MARK	DATE	DESCRIPTIONS	BY	CH'D	CCO#
1	04/02/07	CROSSBEAM KINK	GB	DT	38

SAN FRANCISCO OAKLAND BAY BRIDGE
EAST SPAN SEISMIC SAFETY PROJECT
SELF-ANCHORED SUSPENSION BRIDGE
(SUPERSTRUCTURE & TOWER)

TYPICAL GIRDER DETAILS NO. 15

CAMBER DIAGRAM

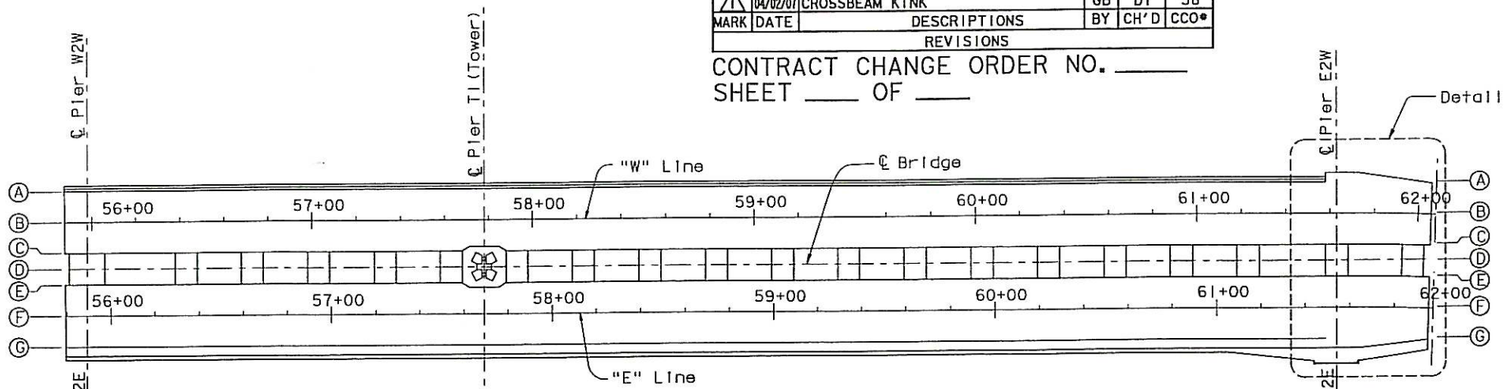
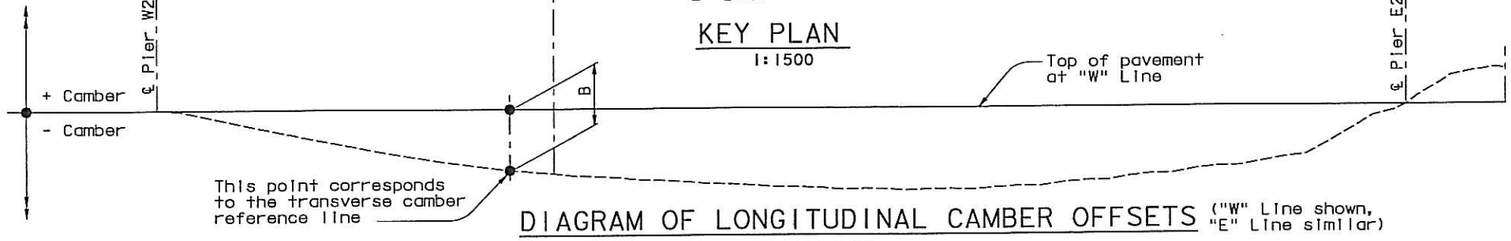
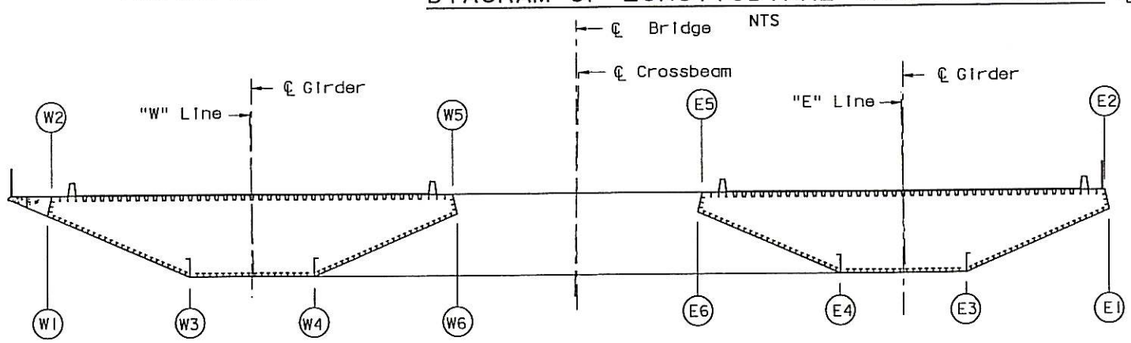
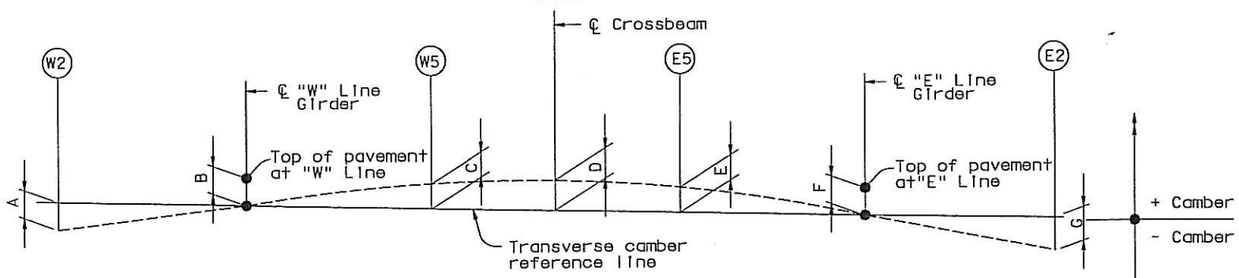
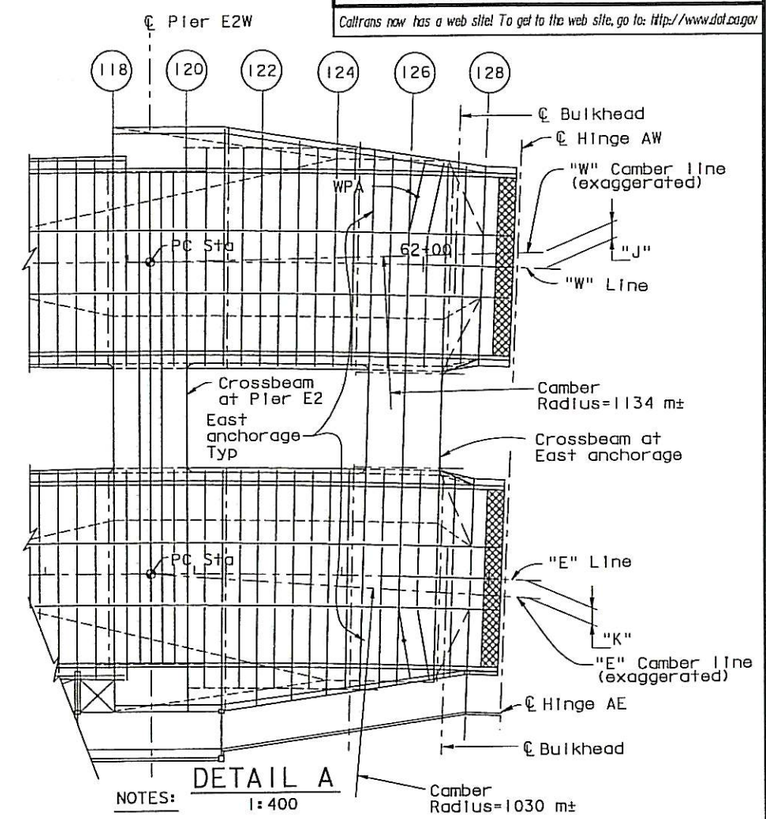
MARK	DATE	DESCRIPTIONS	BY	CH'D	CCO#
1	04/02/07	CROSSBEAM KINK	GB	DT	38

1. For camber schedule and notes, see "Camber Schedule" sheet and "Camber Schedule-A" sheet.
2. The box girders shall also be cambered for axial shortening due to dead load. See table 3 on "Camber Schedule-B" sheet.
3. Crossbeams shall also be cambered for axial strain shortening due to dead load between panel points 118 to 127. The E2 cross beam shall be fabricated 7 mm longer than the nominal dimensions. The east anchorage crossbeam shall be fabricated 7 mm shorted than the nominal dimensions.
4. For typical cross beams (when "E" line and "W" line roadway decks lie in the same plane) the kink due to the transverse camber shall be located at the ℄ of the bolted splice.

CAMBER SCHEDULE-A

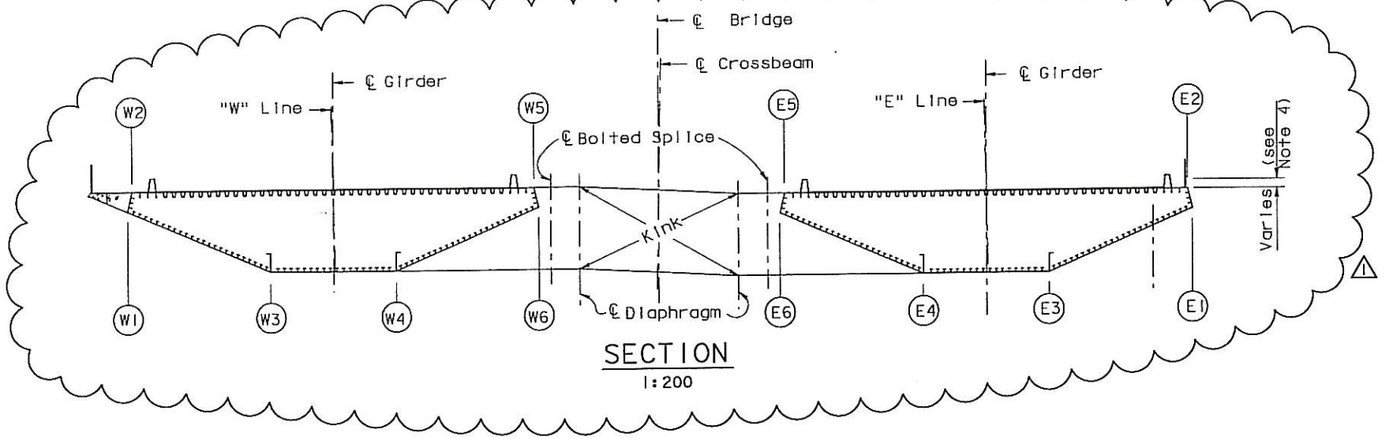
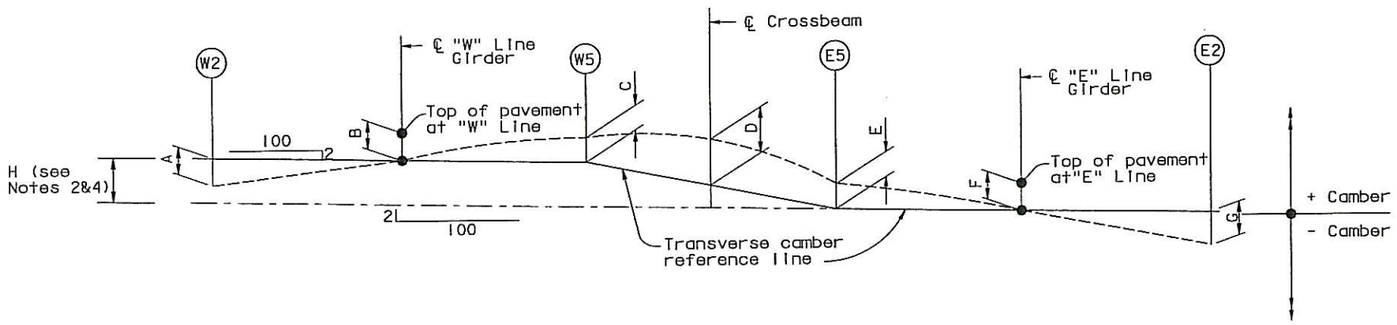
MARK	DATE	DESCRIPTIONS	BY	CH'D	CCO#
1	04/02/07	CROSSBEAM KINK	GB	DT	38

1. For panel point locations not given the camber offsets shall vary linearly between the tabulated values.
2. Dimension "H" varies due to the differing EB and WB vertical curves. "H" is taken to be zero east of "E" 57+30.
3. No additional live load camber is required for the transverse or axial directions.
4. To account for differences in alignment in "E" line and "W" line roadway profiles (which result in a kink and/or twist in crossbeams) for crossbeams at PP 14 to 28, the kink shall be located at the first diaphragm interior to the bolted splice. For details see "Typical Crossbeam Details No. 4" sheet. Crossbeam at East Anchorage is similar. (1)

TYPICAL CROSSBEAM DETAILS NO. 1

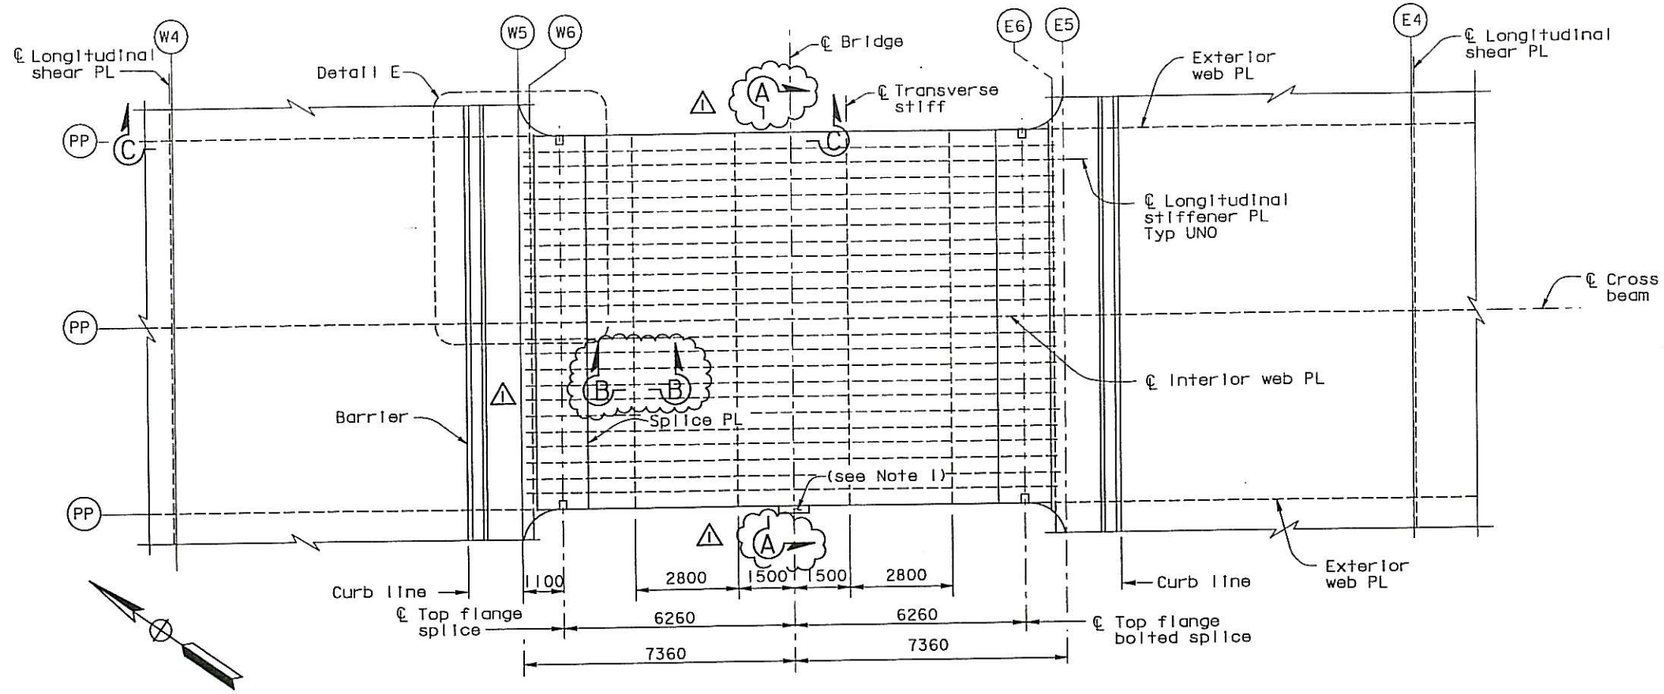
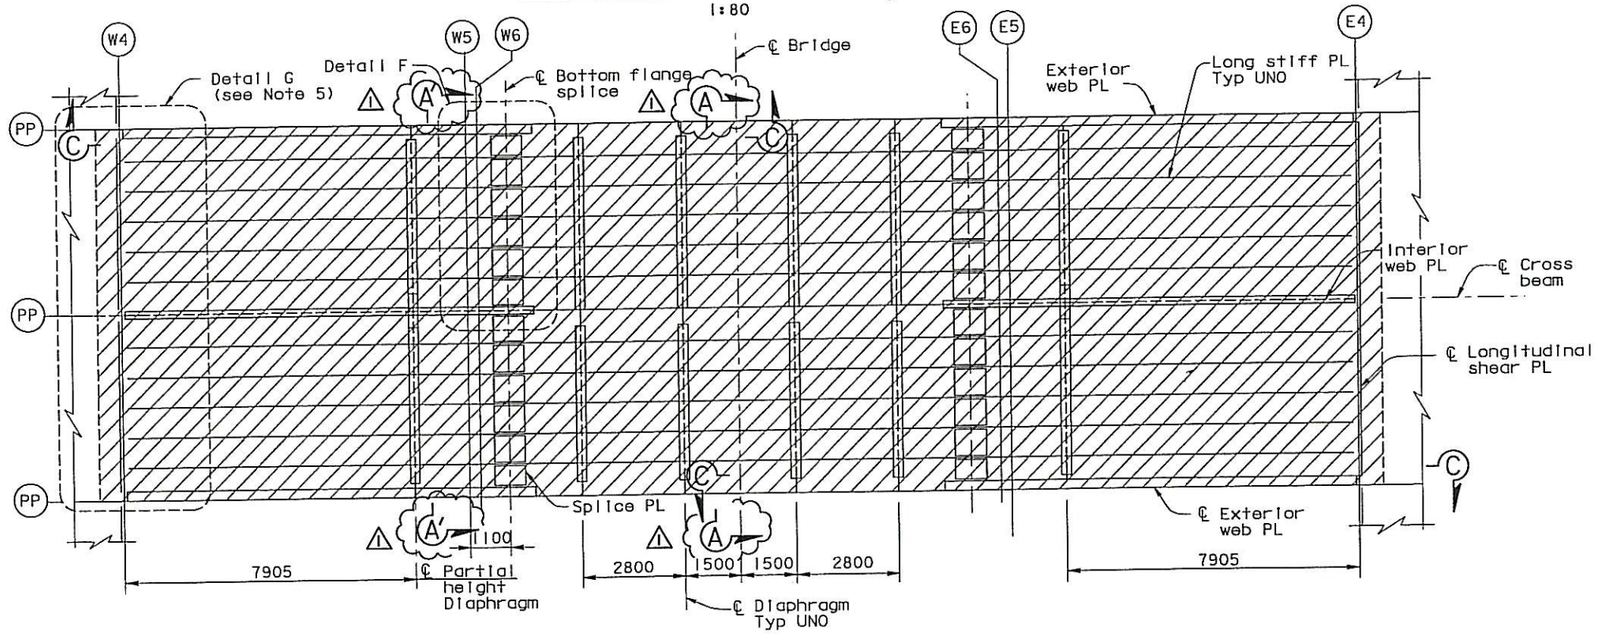
MARK	DATE	DESCRIPTIONS	BY	CH'D	CCO#
1	04/02/07	CROSSBEAM KINK	GB	DT	38

TYPICAL CROSSBEAM DETAILS NO. 2

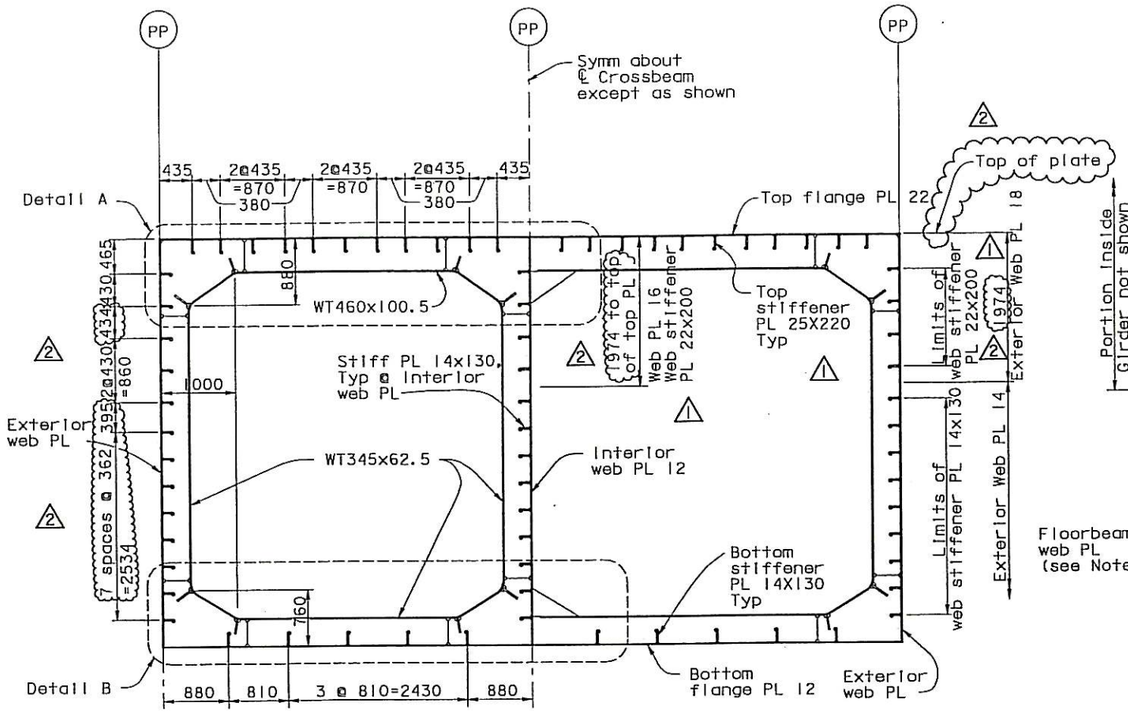
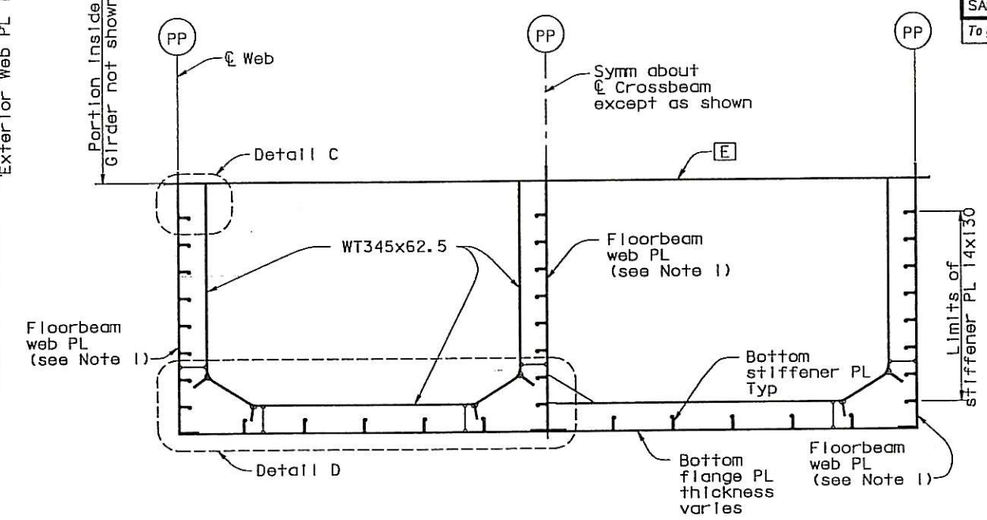
MARK	DATE	DESCRIPTIONS	BY	CH'D	CCO#
2	04/02/07	CROSSBEAM KINK	GB	DT	38
1	06/23/06	STIFFENER SIZE INCREASE	GB	NV	21

TYPICAL CROSSBEAM DETAILS NO. 4

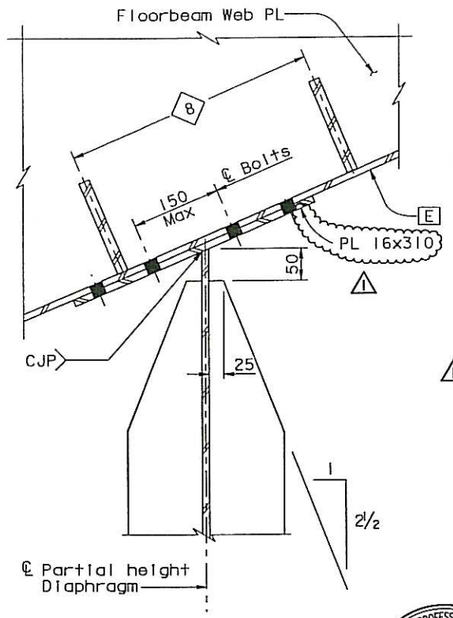
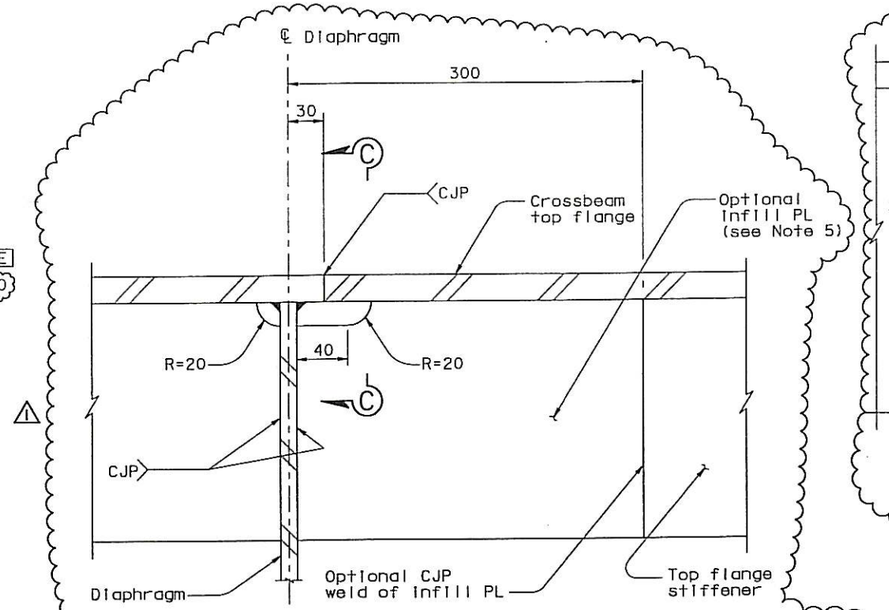
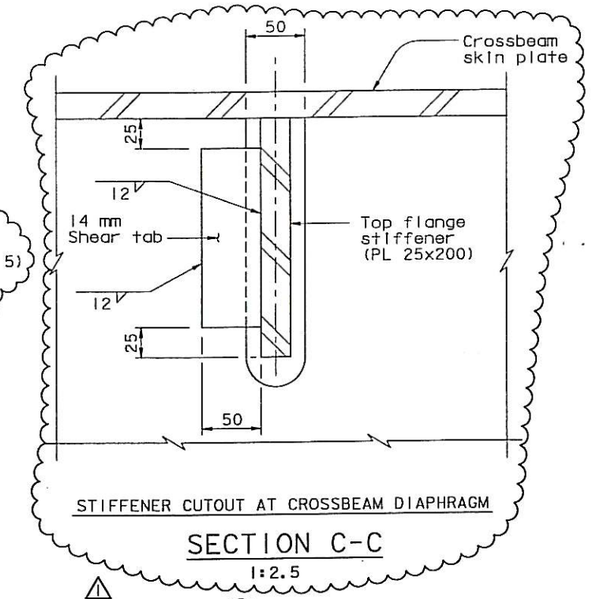
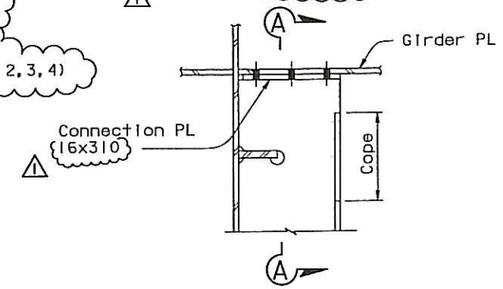
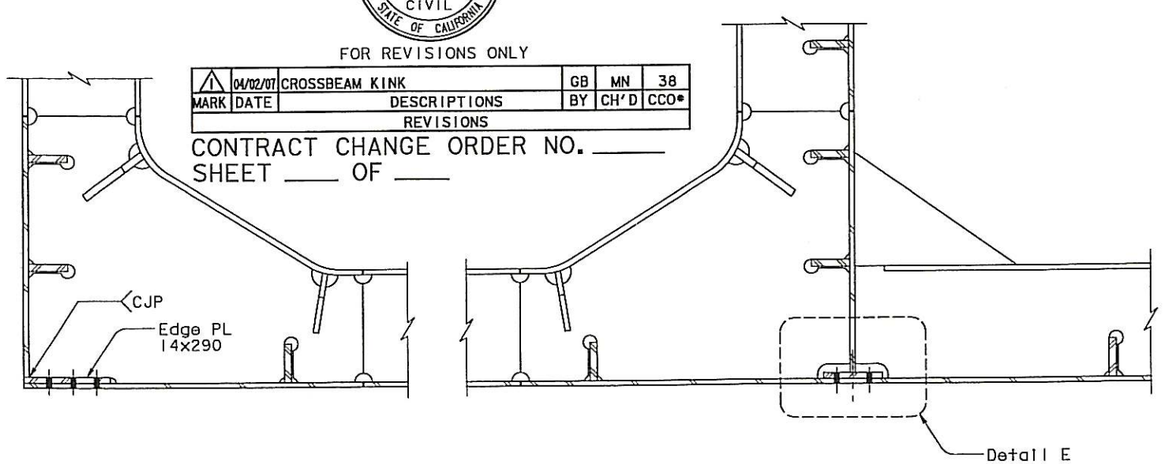
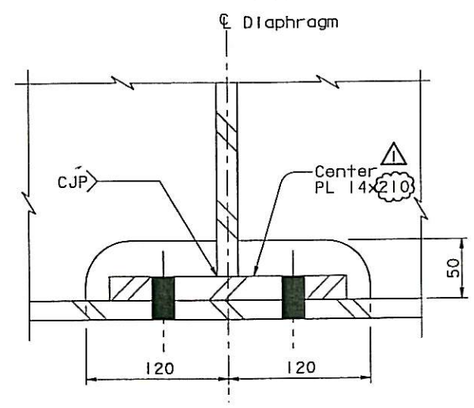
MARK	DATE	DESCRIPTIONS	BY	CH'D	CCO#
1	04/02/07	CROSSBEAM KINK	GB	MN	38

1. For details not shown, see "Typical Crossbeam Details No. 3" sheet.
2. The location of the angular changes to the crossbeam skin plates due to the roadway geometry shall be at the first diaphragm inside the crossbeam field splice, towards the centerline of the bridge.
3. Stiffeners at the angle change, running longtiudinal to the crossbeam, shall be interrupted and welded to the diaphragm with a CJP weld. Stiffeners on opposite faces of the diaphragm shall be aligned within the tolerances specified for stiffener splices.
4. Crossbeam skin plates shall be twisted to accommodate roadway geometry shown on the plans.
5. The Contractor may provide an infill segment in the stiffeners to allow for fit-up. This length shall be welded to skin plate after fit-up.
